**STAFF REPORT**

SUBJECT: Ultra Clean Carwash – CUP  
[H-2023-0073](#)

LOCATION: 715 E. Fairview Ave., in the NW 1/4 of Section 7, T.3N., R.1E.

A. Proposed Site Plan (dated: 2/21/24)

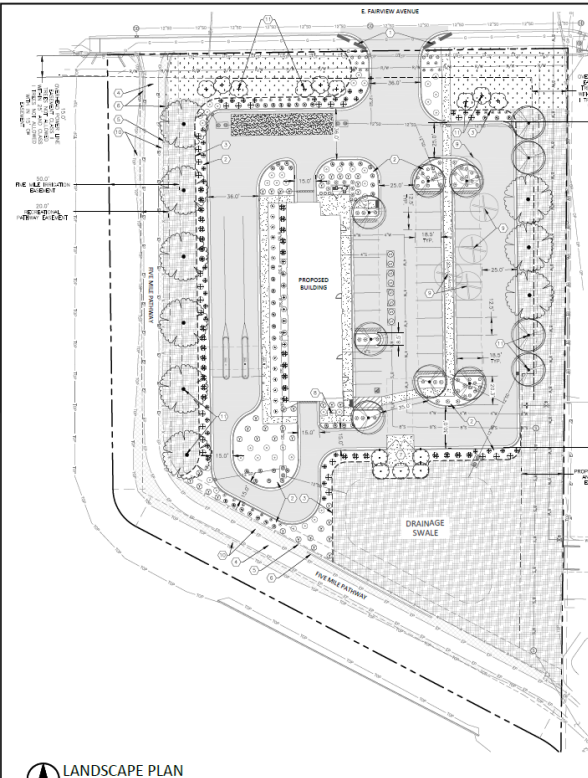
**Access:** One (1) right-in/right-out driveway access is proposed at the northern boundary of the site via E. Fairview Ave., an existing arterial street. The driveway location depicted on the site plan complies with ACHD's requirements.

**Parking:** Off-street parking is required in accord with the standards listed in UDC [11-3C-6B.1](#), which requires one (1) space for every 500 square feet of gross floor area. Based on 5,600 s.f., a minimum of 11 spaces are required; a total of 24 spaces are proposed, exceeding the minimum standards by 13 spaces. Due to the nature of the proposed use, the proposed parking will mostly provide parking for use of the vacuums but will also provide parking for employees.

A bicycle rack capable of holding at least one (1) bicycle is required per UDC [11-3C-6G](#); bicycle parking facilities are required to comply with the location and design standards listed in UDC [11-3C-5C](#). A bike rack is depicted on the site plan that will hold two (2) bicycles in accord with this standard. **A detail should be included on the site plan submitted with the Certificate of Zoning Compliance application that complies with the aforementioned design standards.**

**Trash Enclosure:** The trash enclosure is located along the southern boundary of the parking area. **A receptacle for recycling should be provided within the trash enclosure; a detail should be submitted with the Certificate of Zoning Compliance application that demonstrates compliance.**

1. The site plan and landscape plan submitted with the Certificate of Zoning Compliance application shall be revised as follows:
  - a. Include a detail for the trash enclosure that includes a recycling receptacle in the enclosure.

- e. Include a detail of the bicycle rack that demonstrates compliance with the standards listed in UDC [11-3C-5C](#).
  - f. Depict a minimum 20' wide driveway within a cross-access ingress/egress easement to the adjacent property to the east (Parcel #S1107120807).

# C. Building Elevations (dated: 10/26/23)

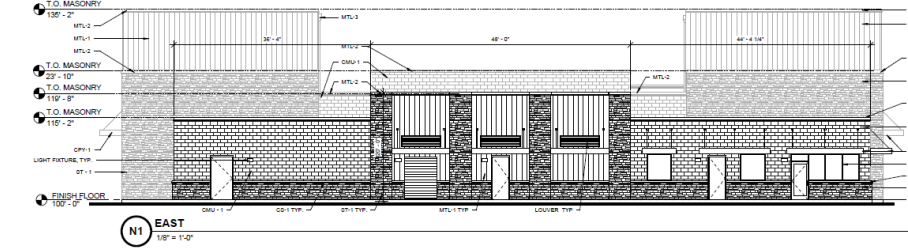
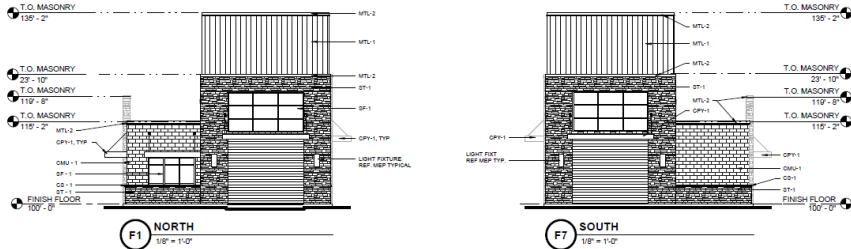
**Building Elevations:** Conceptual building elevations were submitted as shown in Section VIII.C for the proposed vehicle washing facility that depict modulation and articulation on all facades with belly bands, awnings, metal cladding designed to look like cedar, glazing and other architectural features. A mix of materials are proposed consisting of burnished CMU, natural stone, cedar rendition metal cladding and other natural materials with metal roofing and canopies. The color scheme will include various browns, tans, and other warm earth tones. **The final design is required to be consistent with the design standards listed in the [Architectural Standards Manual](#).**
